HISTORIC AND DESIGN REVIEW COMMISSION

March 17, 2021

HDRC CASE NO: 2021-068
ADDRESS: 321 CLUB DR
LEGAL DESCRIPTION: NCB 6704 BLK 14 LOT 5- 6, E 18 FEET OF 7
ZONING: R-6, H
CITY COUNCIL DIST.: 7
DISTRICT: Monticello Park Historic District
APPLICANT: TREVINO JOHN C & PATRICIA V
OWNER: TREVINO JOHN C & PATRICIA V
TYPE OF WORK: Demolition of existing addition with new construction
APPLICATION RECEIVED: February 02, 2021
60-DAY REVIEW: Not applicable due to City Council Emergency Orders
CASE MANAGER: Huy Pham
REQUEST:

The applicant is requesting a Certificate of Appropriateness for approval to remove the existing rear addition and construct a new addition in the same location.

ELEVATIONS PROPOSED ADDITION
SCALE: 1/8" = 1'0"

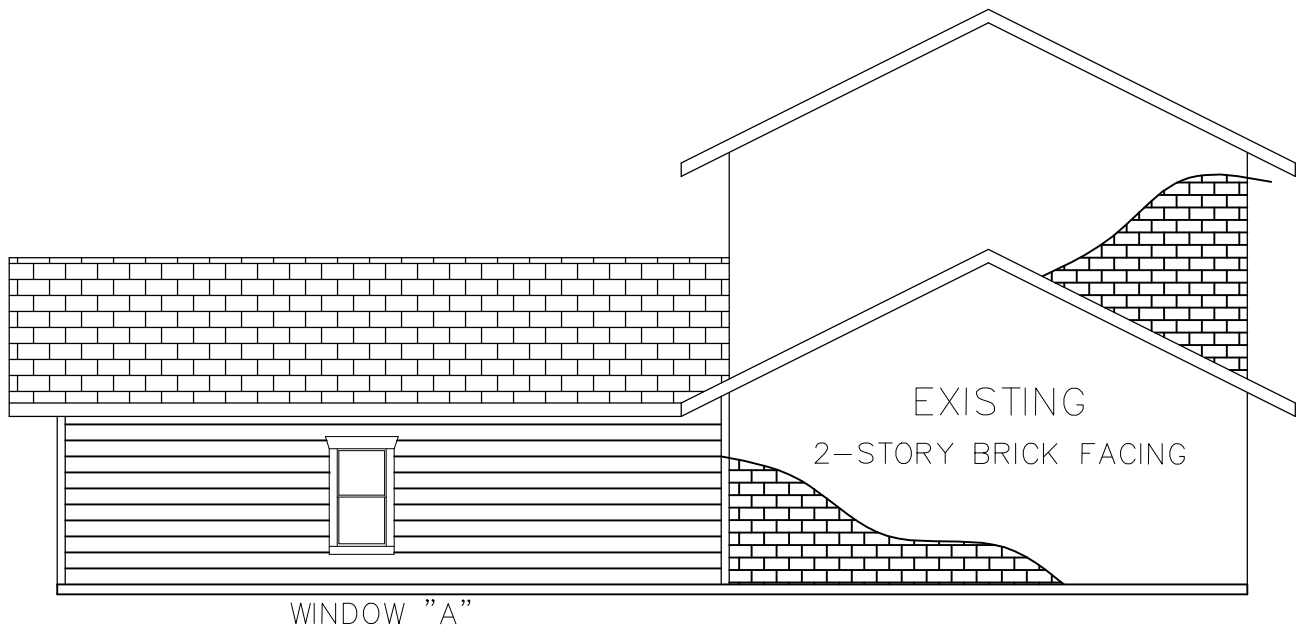
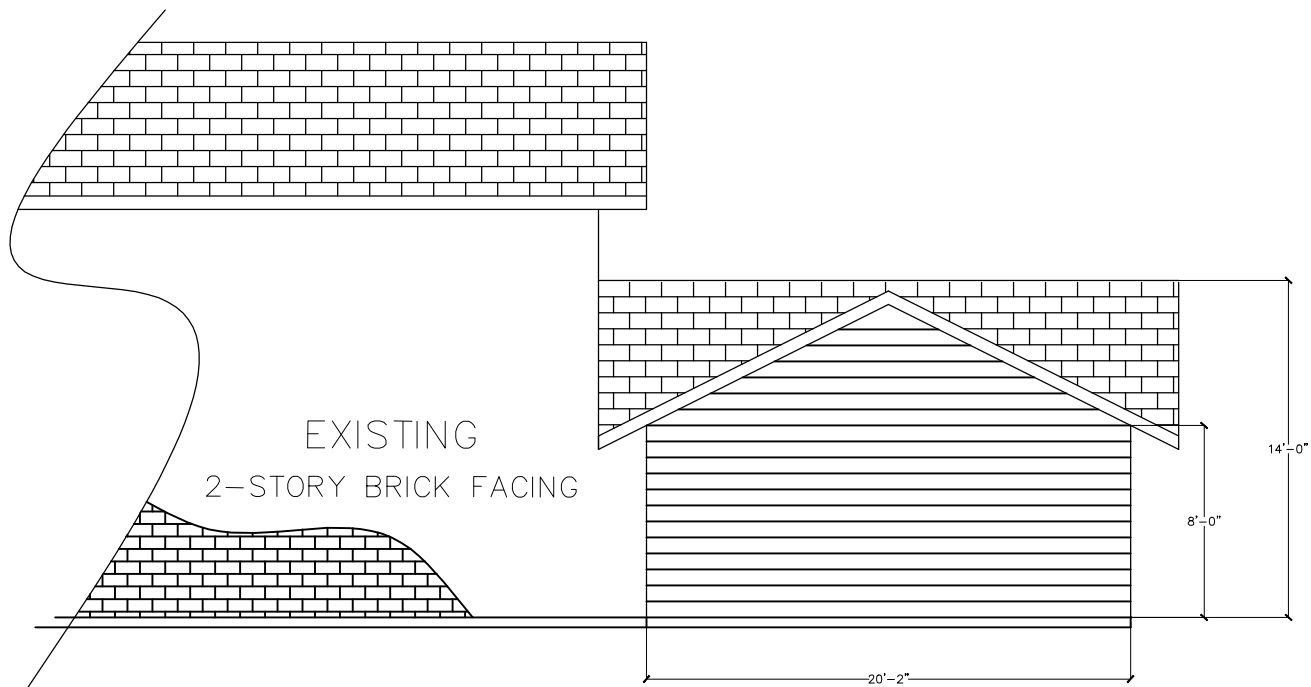
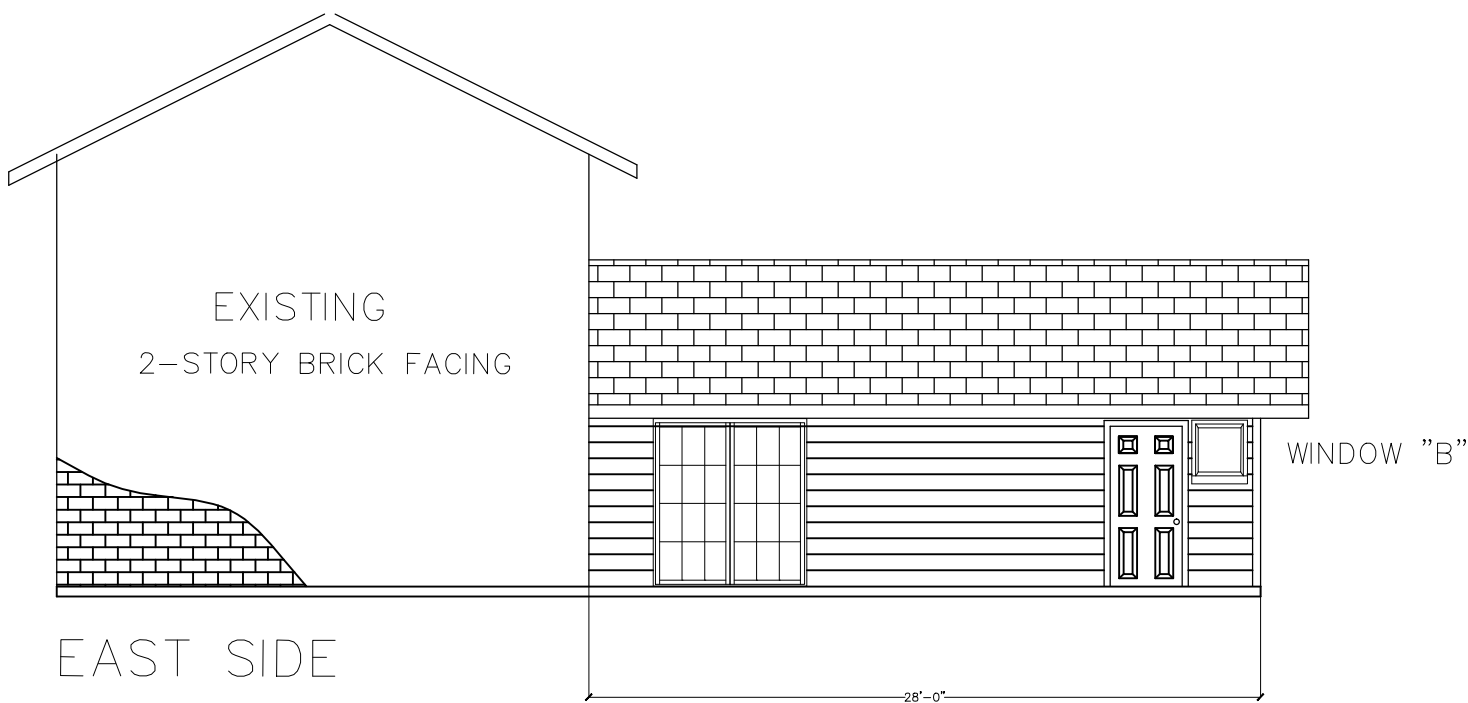
- g. ADDITION HEIGHT – Per the Guidelines for Additions 1.B.v., generally, the height of new additions should be consistent with the height of the existing structure; the maximum height of new additions should be determined by examining the line-of-sight or visibility from the street; and the addition height should never be so contrasting as to overwhelm or distract from the existing structure. Staff finds the proposed maximum height of 14' matching the existing one-story garage is appropriate.

- h. ADDITION MATERIALS – Per the Guidelines for Additions 3.A.i., applicant should use materials that match in type, color, and texture and include an offset or reveal to distinguish the addition from the historic structure whenever possible; any new materials introduced to the site as a result of an addition must be compatible with the architectural style and materials of the original structure. The applicant has proposed to utilize cement board siding (eg. Hardie plank) and composition shingle roof. Staff finds the proposed materials are generally appropriate with the stipulation that the cement boarding siding should feature a traditional 4" lap exposure and feature a smooth finish; no faux wood grain is allowed.

- j. ADDITION FENESTRATION & WINDOWS – The applicant has proposed an addition that features a set of French doors, a pedestrian door, and a square picture each matching in head height facing the interior lot and a one-over-one sash window facing the side neighbor. Staff finds the proposed fenestration pattern is generally appropriate with the stipulation that the final window product adheres to the Standard Specifications for Windows in New Construction and Additions.

- i. That the siding features a traditional 4-inch lap exposure and a smooth finish; no faux wood grain is allowed.
- ii. That the final window product adheres to the *Standard Specifications for Windows in New Construction and Additions*. While no material is expressly prohibited by the Historic Design Guidelines, a high-quality wood or aluminum-clad wood window product often meets the Guidelines with the standard stipulation. If the proposed window does not meet the aforementioned stipulations, then the applicant must submit updated window specifications to staff for review, prior to purchase and installation.
